<b>Project</b>	13494 Hampton Pre-Prep School		
<b>Date</b>	8 March 2024	<b>Memo No</b>	M001
<b>Memo to</b>	Verity Moria, Hampton School		
<b>From</b>	Ian Rees MIOA	<b>Checked by</b>	Andy Thompson MIOA

## HALL EXTENSION - CHANGES TO LINK SECTION

Figure 1 - Proposed ground floor plan showing revised link section

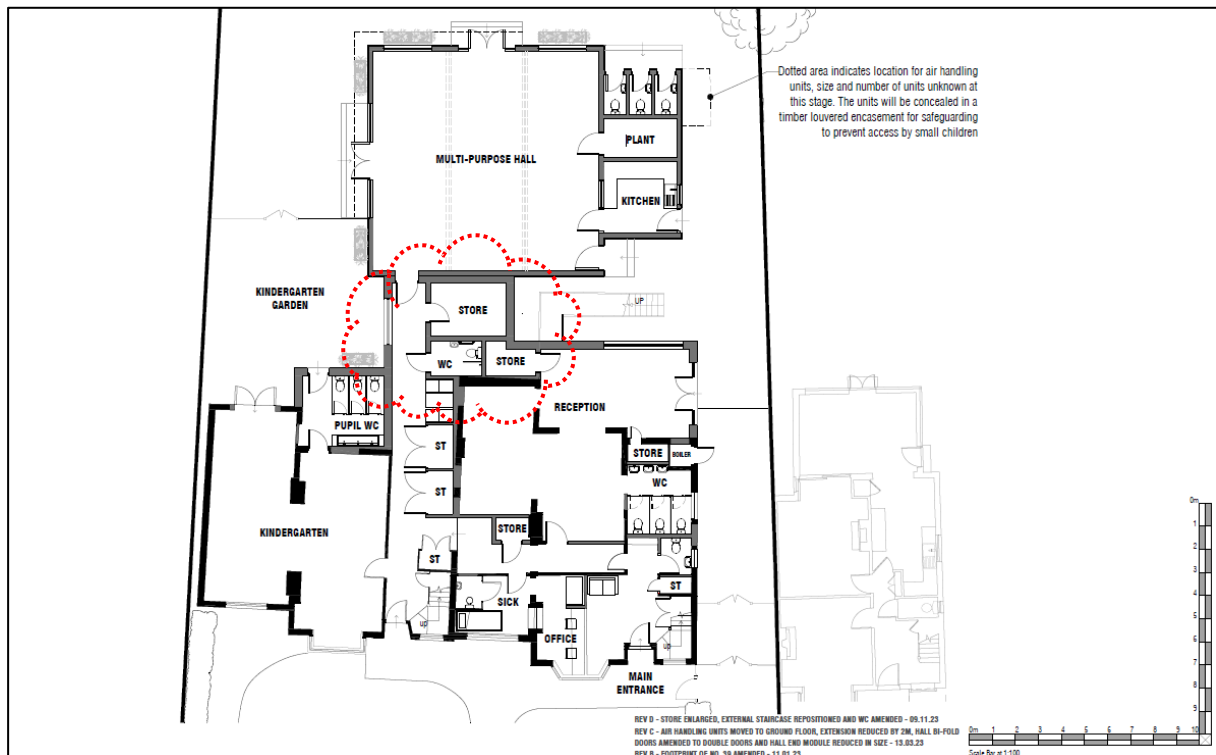
We understand that the minor changes have been proposed to the link section and escape stair between the existing building and proposed hall extension. The revised ground floor plan is shown in Figure 1, with the link section clouded.

There are no significant changes to proposals for the hall extension, reception classroom or kindergarten. We therefore do not expect any significant change to proposed activity noise levels. The proposed change to the link section therefore would not result in increased noise impact to neighbouring properties.
